0-3608

XV.D. CENTRAL NEIGHBORHOOD
3. DOWNTOWN PLAN

Figure C-5: Downtown Height and Design Districts

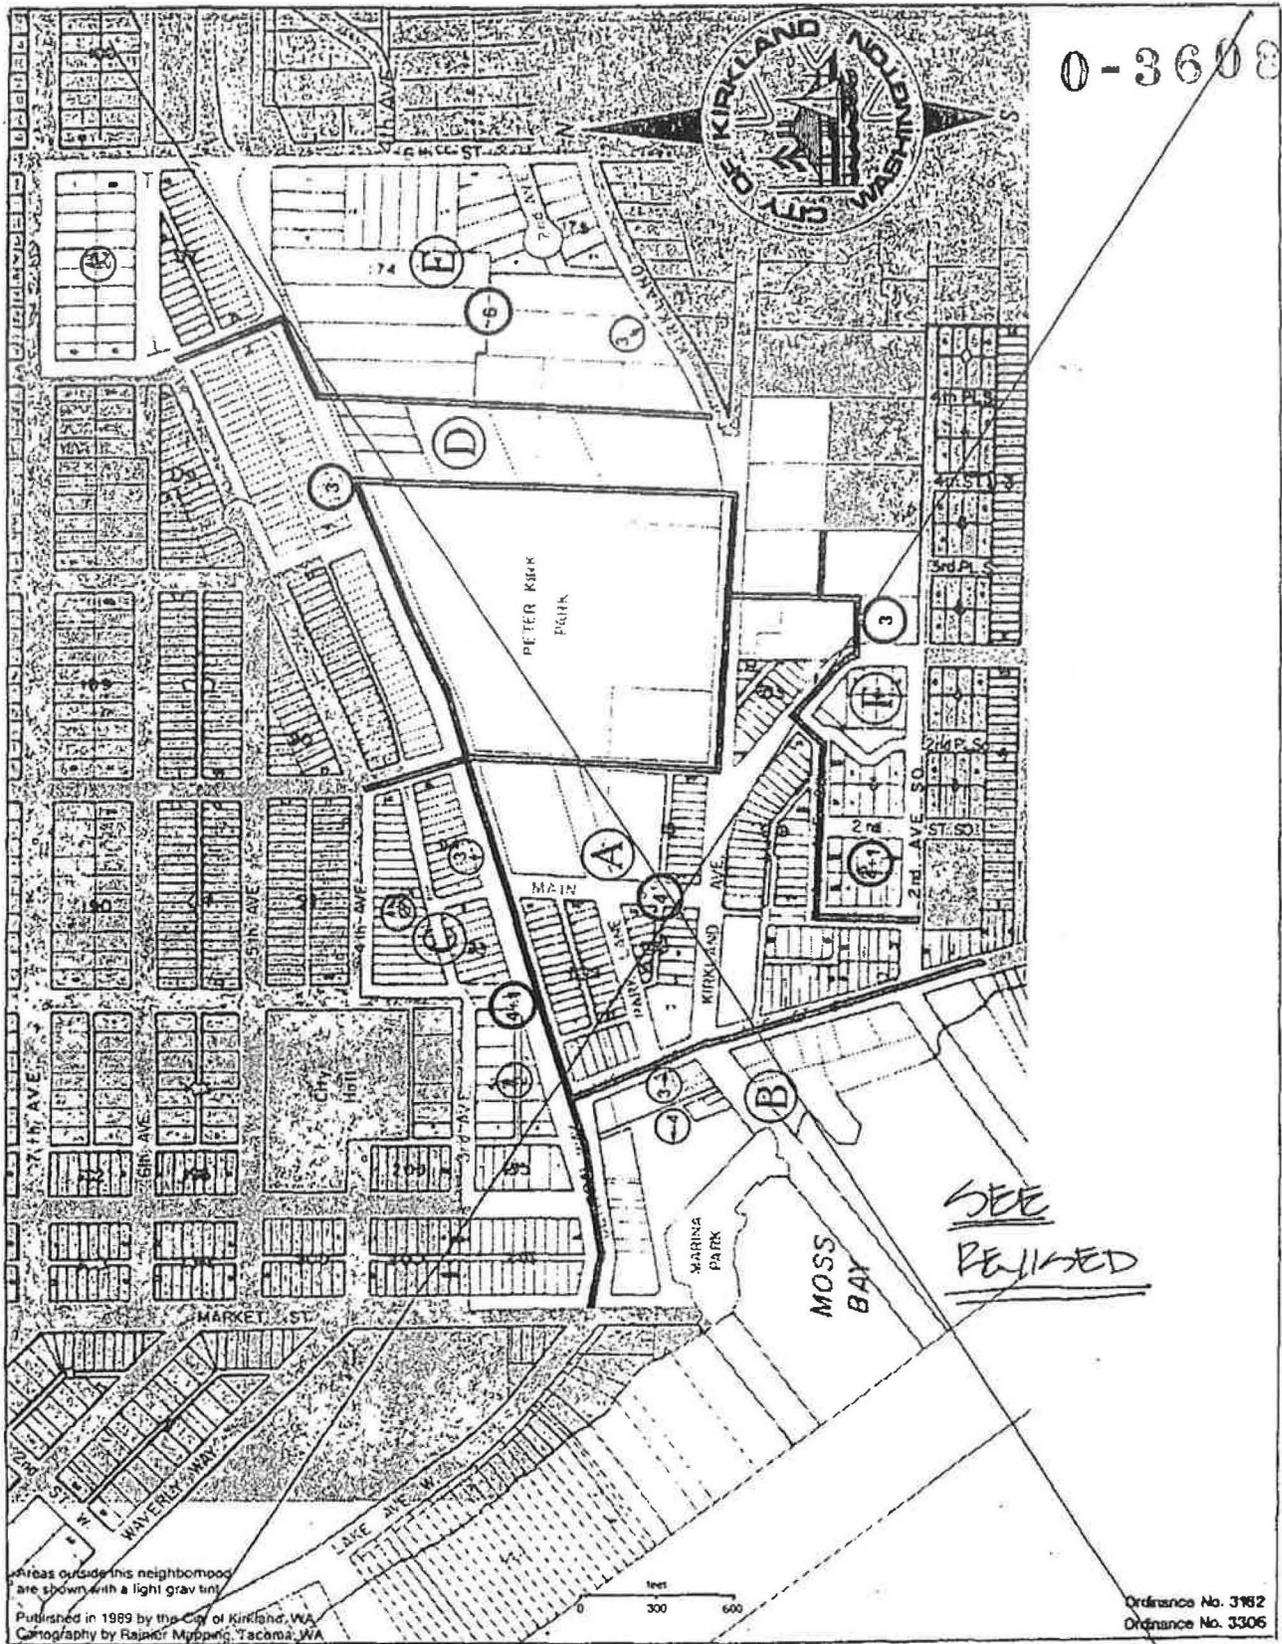
Maximum building height is three stories in Design Districts D 3 and 7.

Maximum building height to be four stories, with a potential for five stories if public parking is provided.

~~for public parking beneath a proposed structure, and the provision of a number of parking stalls dedicated to the public.~~

~~In order to determine the developer's contribution to the public parking, a different parking ratio for a building with a proposed fifth floor could be used.~~

~~Building heights in the portion of District F which lies to the east of 2nd Place South should be limited to three stories.~~

Building heights of two to six stories are appropriate in Design District E 5.

Figure C-6: Design Districts E 5 and 6 - Circulation and Gateways

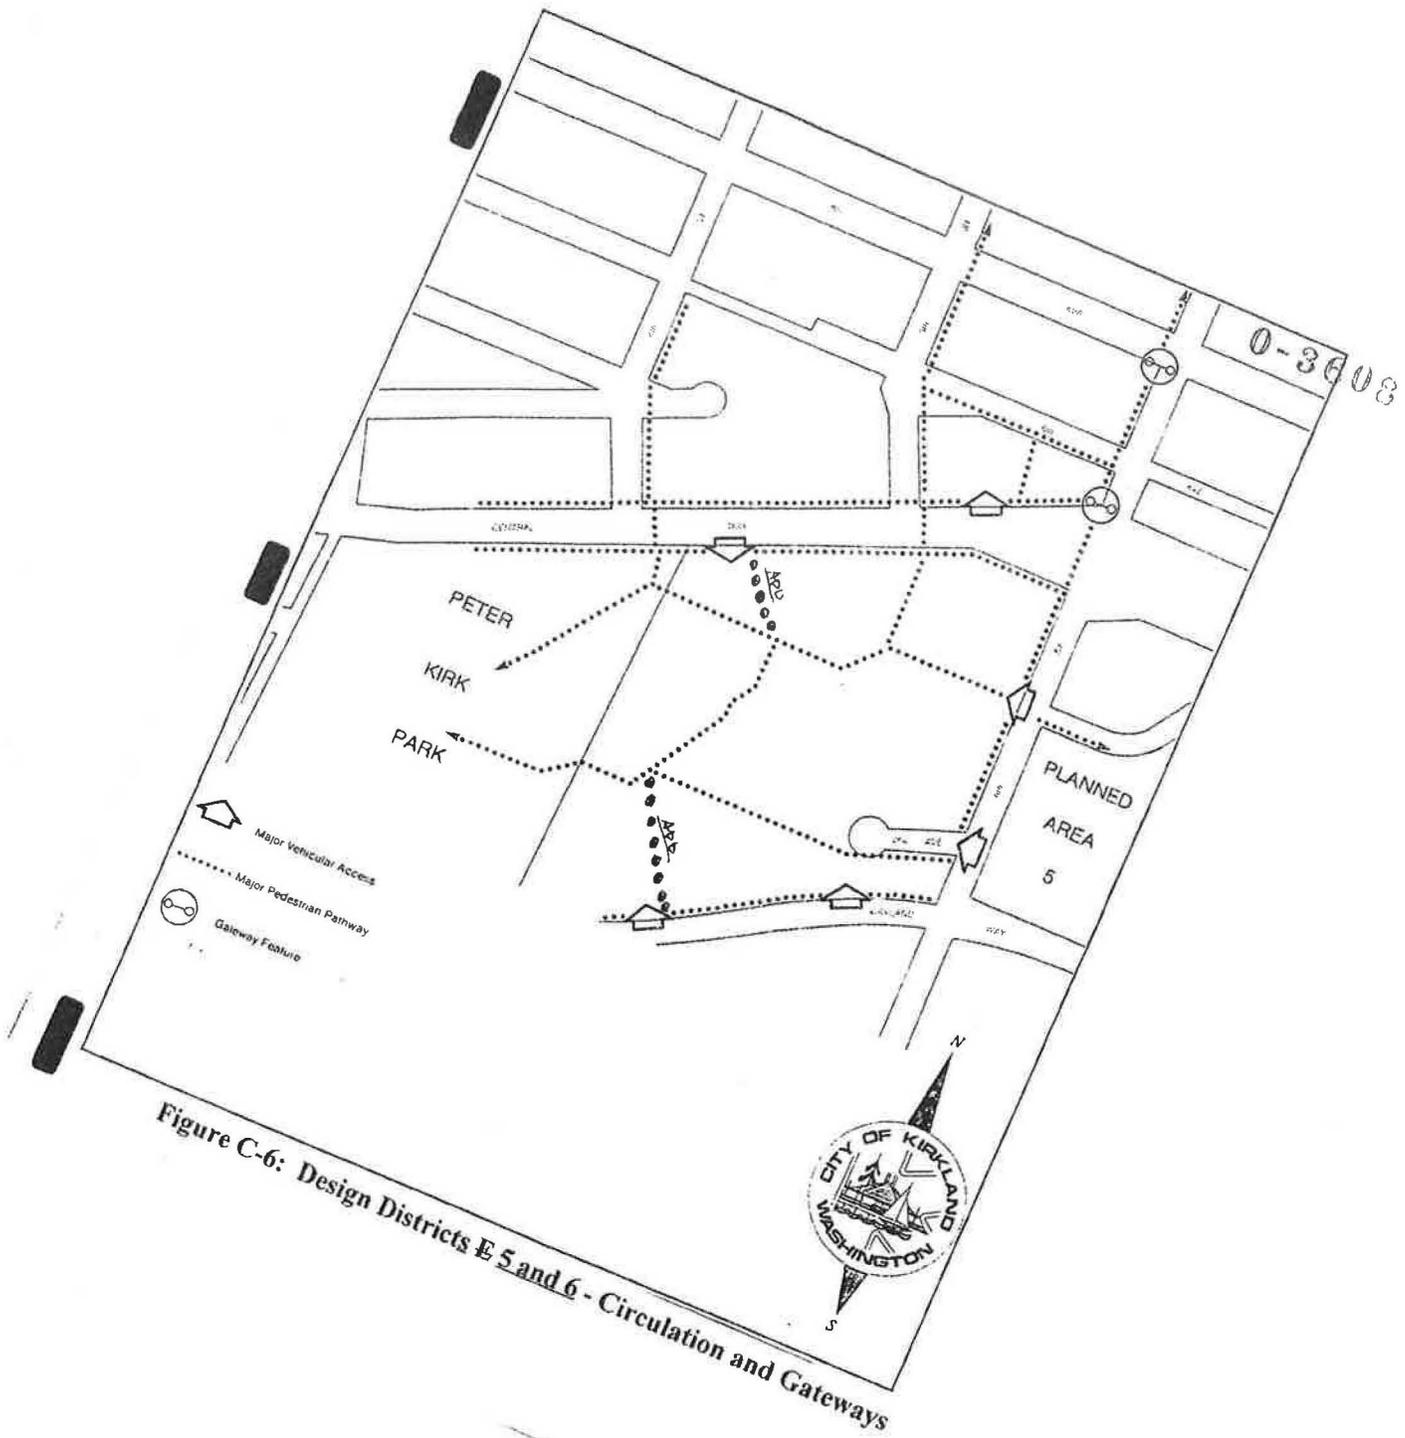
Access, site design, and land use considerations for northern portion of Design District E are discussed. Maximum building heights of two to four stories are appropriate for Design District 6.

~~Vehicular traffic flow to and from this site should be limited to Central Way and the commercial side streets. A physical barrier or partial street vacation may be necessary to protect residential areas north of 7th Avenue from excessive commercial traffic.~~

A ~~s~~Safe, convenient, and attractive pedestrian connections across the site district should be provided. This path should be designed under a covered enclosure or arcade along the storefronts in this area. Visual interest and pedestrian scale of these storefronts will contribute to the appeal of this walkway to the pedestrian. A connection of this pathway to Central Way should be made, with a continuation of the overhead enclosure to unify this pedestrian route.
